# MINUTES OF MEETING

## LOCAL TRAFFIC COMMITTEE MEETING

Venue	Conference Room, Station Street, Mullumbimby
Date	Tuesday, 17 August 2021
Time	10.30am
Committee Members	Penny Sutton – Transport for NSW Detective Chief Inspector Matt Kehoe – Police Cr Basil Cameron Tamara Smith MP

**Report No. 6.1      Lilium Love Cafe, Huonbrook Rd (No Stopping)**  
**File No:              I2021/1001**

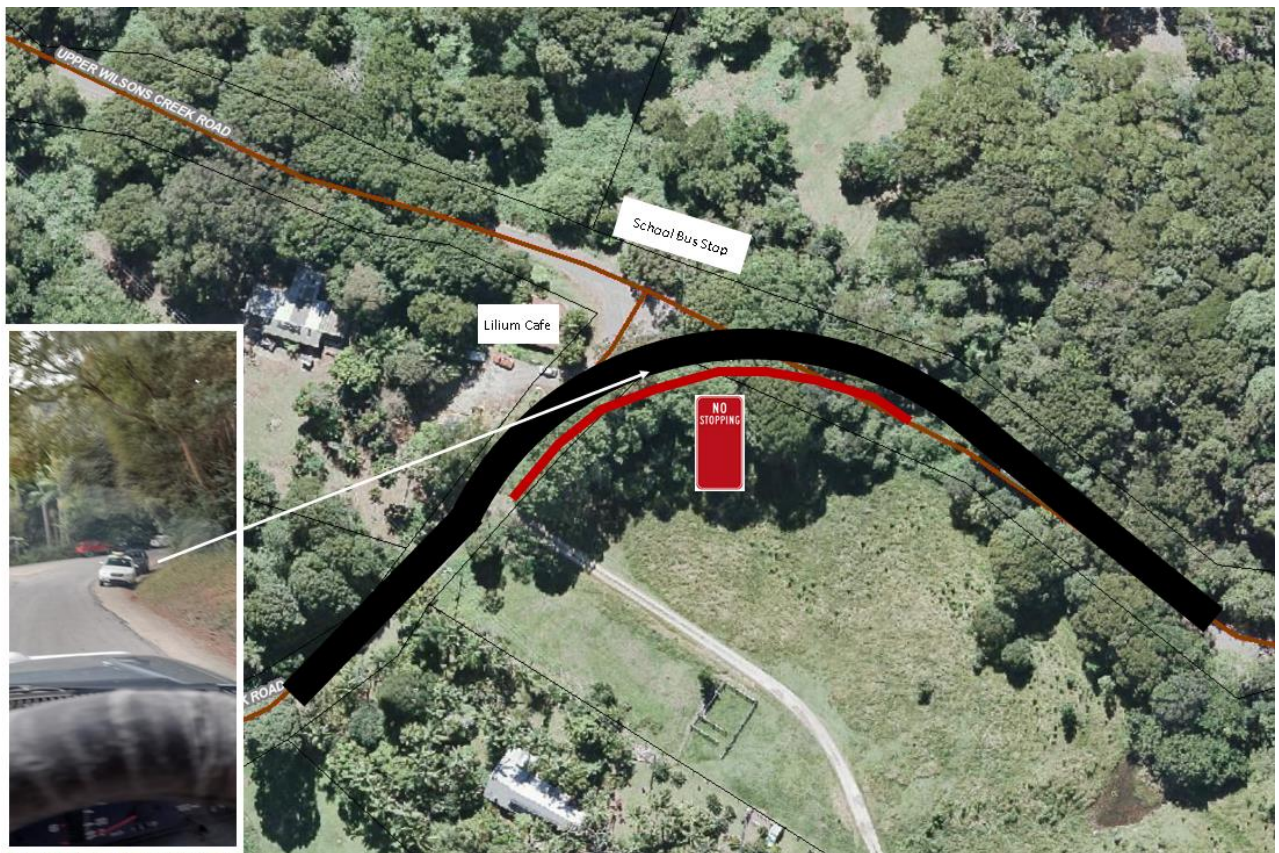
Lilium Love Café is located at the intersection of 3 roads: Wilsons Creek Road, Upper Wilsons Creek Road and Huonbrook Road. In addition, there is a busy informal school bus stop located here. Especially during peak drop off and pick up times cars parking in dangerous locations and the installation of No Stopping signs in the location shown by the red line below will help reduce the risk associated with this intersection.

Therefore, staff propose to install No Stopping signs along the inside curve of Hounbrook Road / Wilson Creek Rd intersection.

Note the situation of conflicted bus zone safety issues are replicated in multiple locations on hinterland road network and serious safety issues detailed in recent Council survey feedback on provision of bus stops and zones. There is a disconnect between funding for DDA 'compliant' bus stops and the fact that the majority of bus patrons do not use these sites and remain largely unprotected at drop off and pick locations along routes.

- 1. That Council supports the installation of No Stopping signs along the inside curve of Hounbrook Road / Wilson Creek Rd intersection for approximately 50m either side of the intersection.**
- 2. That Council considers advisory signs for bus stop/routes ahead to improve safety for bus passenger along Hinterland roads.**

**Event application - Compass Club East Marathon - Byron Bay**  
**I2021/1168**

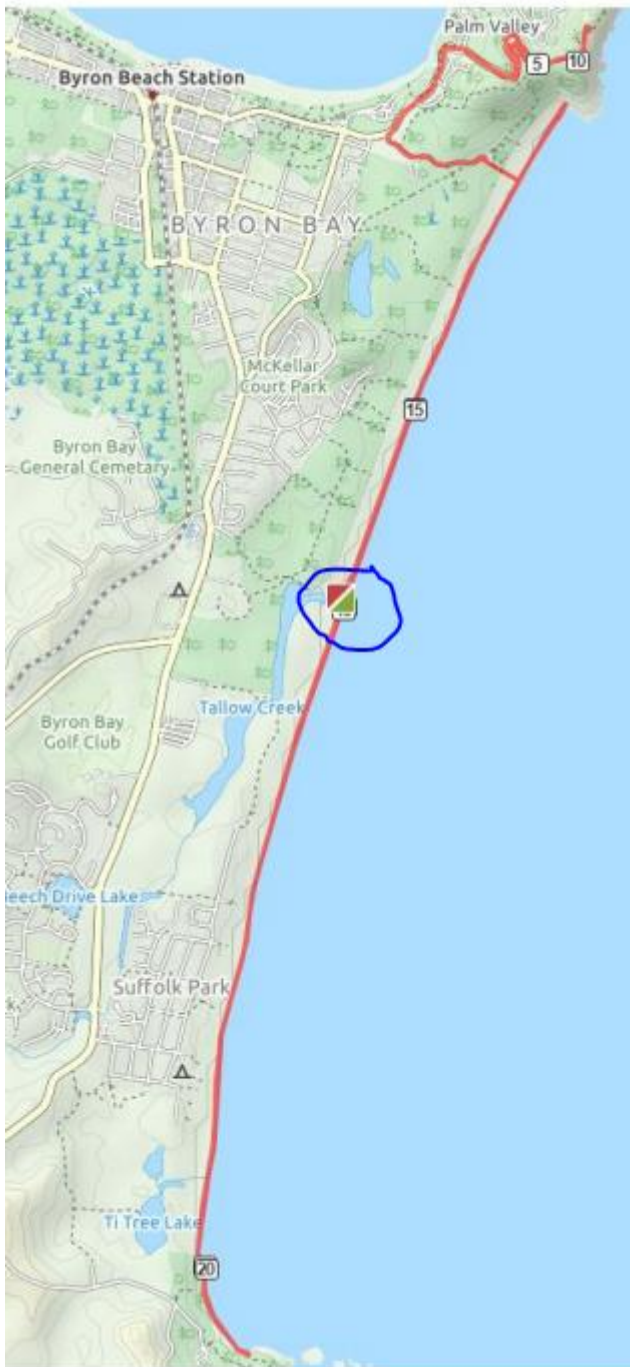
The image below shows the proposed route and impacted roads. In summary, the route follows the following approximate path:

- Start / finish point is halfway down Tallows Beach. Refer to the blue circle in the image below.
- Courses heads north along the beach towards Tallows Beach Road
- North along Tallows Beach Road to Lighthouse Road (subject to NPWS support)
- East along Lighthouse Road to the lighthouse
- Return along Lighthouse Road and Tallows Beach Road to Tallows Beach
- South along Tallows Beach to Broken Head
- From Broken Head return north to finish line.
- It is proposed to control traffic along Lighthouse Road between 6am to 8am. Full

Police: Residents should be able to access Watergong, the Pass etc. Not supporting total closure of Lighthouse Road.

TfNSW: devices that organisers want to implement to be approved

Committee to receive: Detailed plans with regulatory signages, COVID-19 plans, full traffic management plan

**This report to be deferred to the next extraordinary meeting of LTC in October after receiving detailed plans from organisers.**

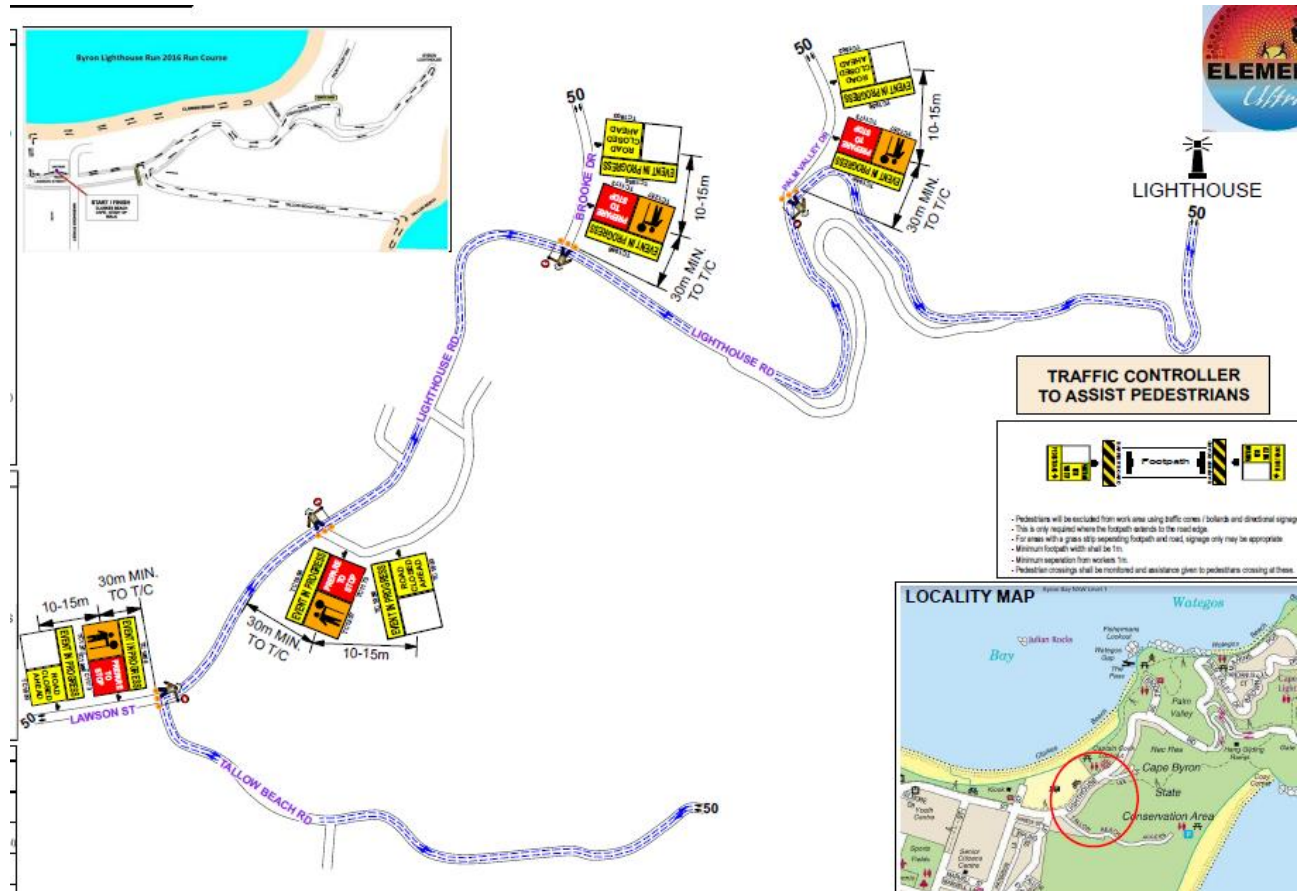
While a TMP or event specific TCP have not been submitted, a TCP related to the 2016

Byron Half Marathon has been submitted to demonstrate the expected road closures outlined above for Tallows Beach Road and Lighthouse Road. Refer to attachment 1.

### **Original approved Location in DA10.2013.587.1**

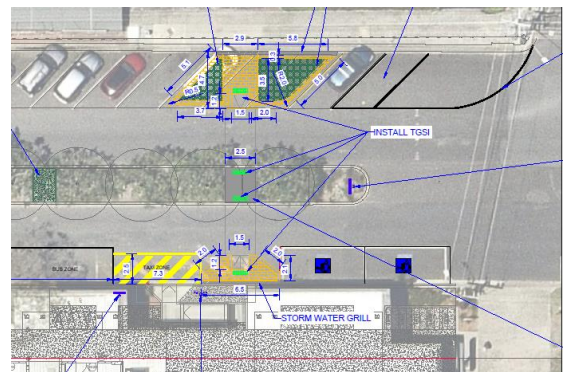
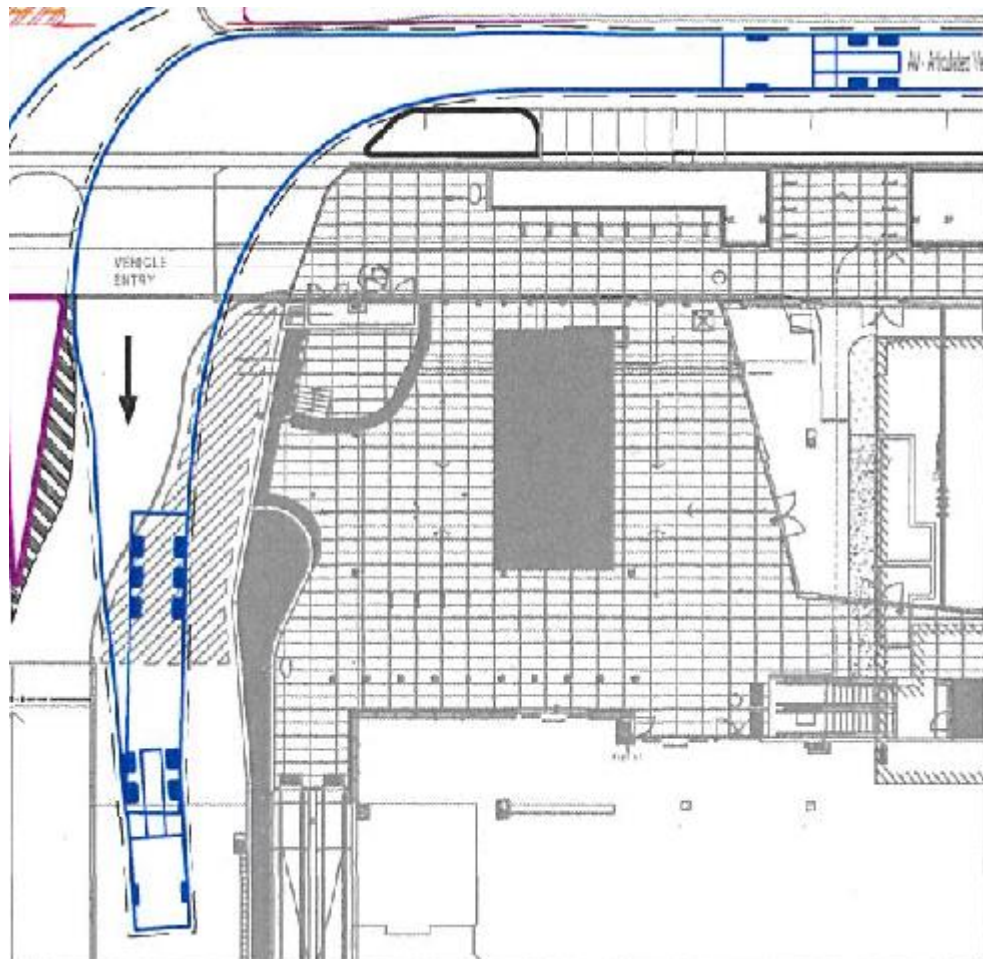
This is situated near the development access (see above). This location will reduce the angle parking supply by a maximum of 3 parking spaces on the east side of Jonson St and no reduction of parking spaces west of Jonson St. A net parking supply reduction of three (3).

This location is close to Mercato building's main entrance providing the shortest distance for pedestrians (approximately 5m) to gain entry and exit of the development and currently being used by the majority of pedestrian crossing in the Jonson St.

It is envisaged that the pedestrian crossing will be constructed within the raised island as shown on the access layout of the development (see below) and the maximum sized vehicle accessing the site is an articulated vehicle (AV). As shown below, the location of the raised island does not interfere against the traffic lines of the maximum sized vehicle accessing the development site.

The proposed location is situated near Kingsley St intersection (see above). The proposal will involve the removal of one taxi rank space to accommodate a ramp down for pedestrians to cross the street. The works will also involve a ramp on the other side of the street with complimenting landscaping, new line marking and the relocation of one car space to make room for the pedestrian ramp across the road.

The proposal offers more details than the approved location however the proposal will provide a greater impact to the supply of the existing taxi ranks adjacent the development and parking.

The proposal also offers to relocate one angle car space close to Kingsley St intersection. This proposal does meet the no-stopping distance space requirement near a priority intersection (minimum 10m). The net parking supply reduction are three (3) angle parking and one (1) taxi rank. No justification provided why the reduction of one (1) taxi rank is acceptable.

This location also provides a longer travel path from the main entrance of Mercato to travel approximately forty (40m) minimum along the frontage of the development.

The comparison based on the criteria above found that the originally approved location in DA10.2013.587.1 will provide a more suitable location than the new proposal.

It is recommended that the new proposal is not supported and the adoption of the approved location in DA10.2013.587.1 be endorsed.

2. That LTC be provided with updated plans and details including pedestrian facility in original approved location, bus stop, taxi rank, motorcycle parking with relation to regulatory signage for consideration and recommendations for approval at the next LTC meeting.
3. That a priority with supporting signage is established to the crossover to pedestrians and cyclists.
